Appln No. 10/562,171
Amdt. Dated August 6, 2008
Response to Office Action of February 6, 2008
Annotated Sheet # 1

Fig. 1

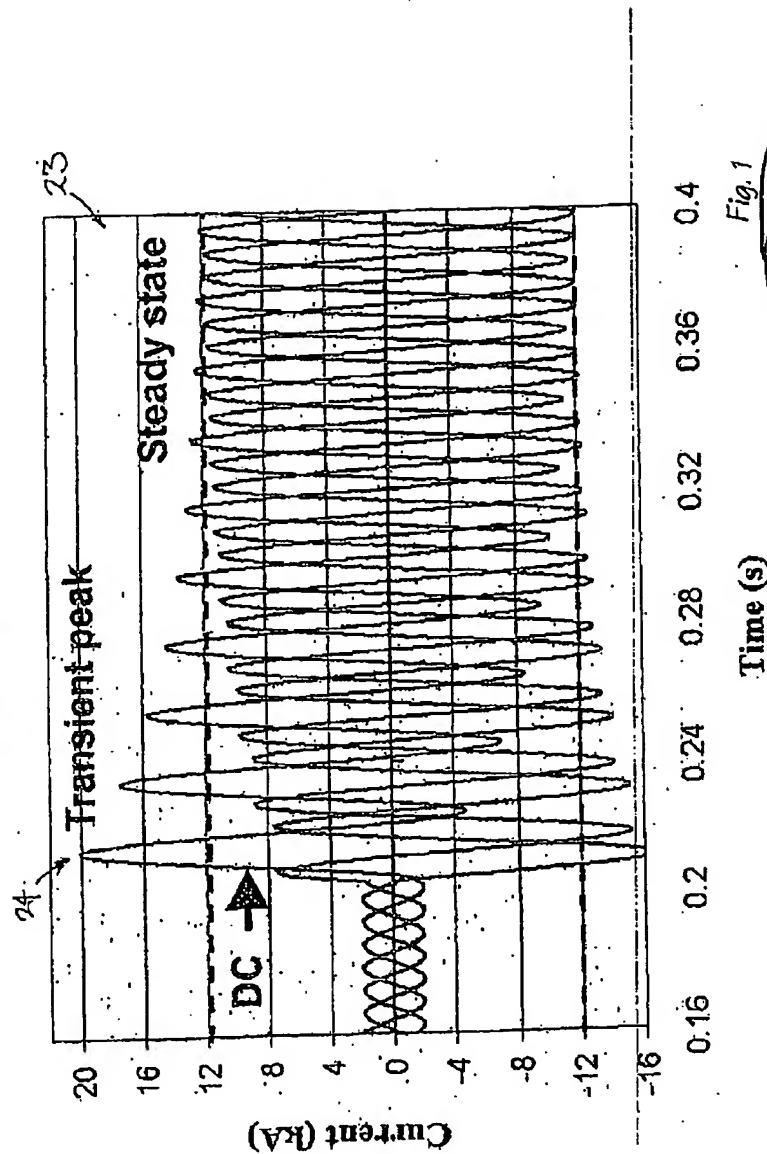
PRIOR ART

Added

Fig. 2

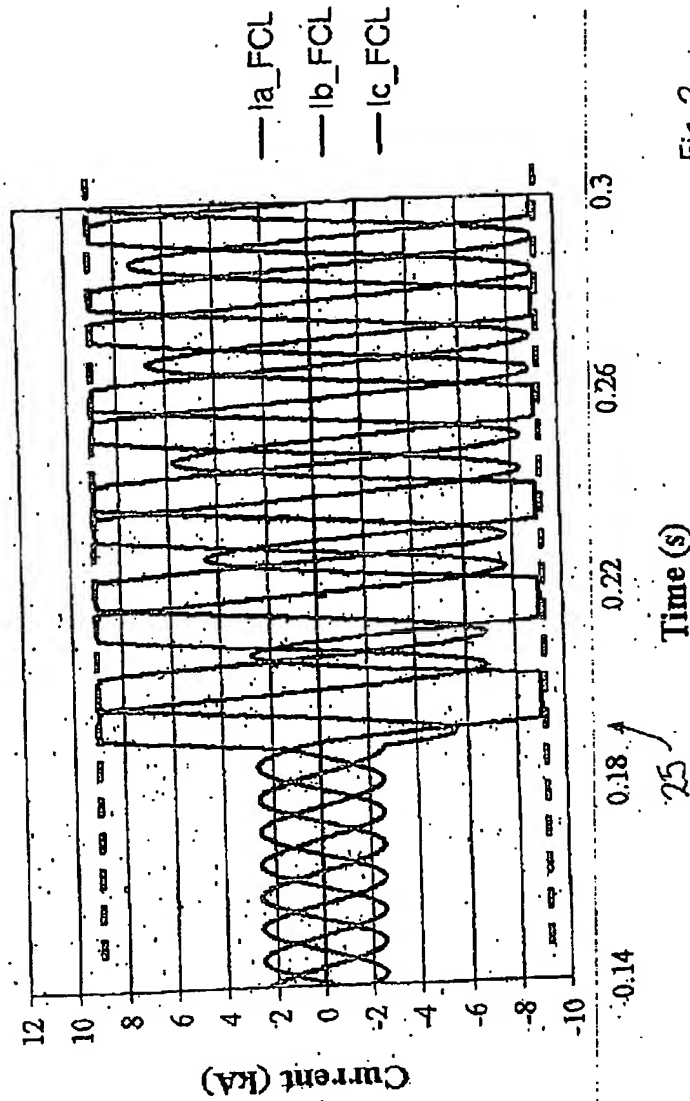
PRIOR ART

added →

Fig. 3
 PRIOR ART

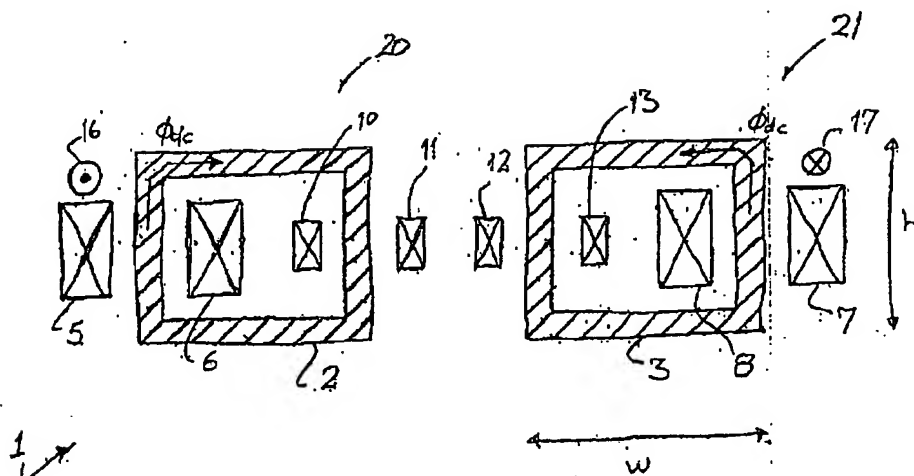
added
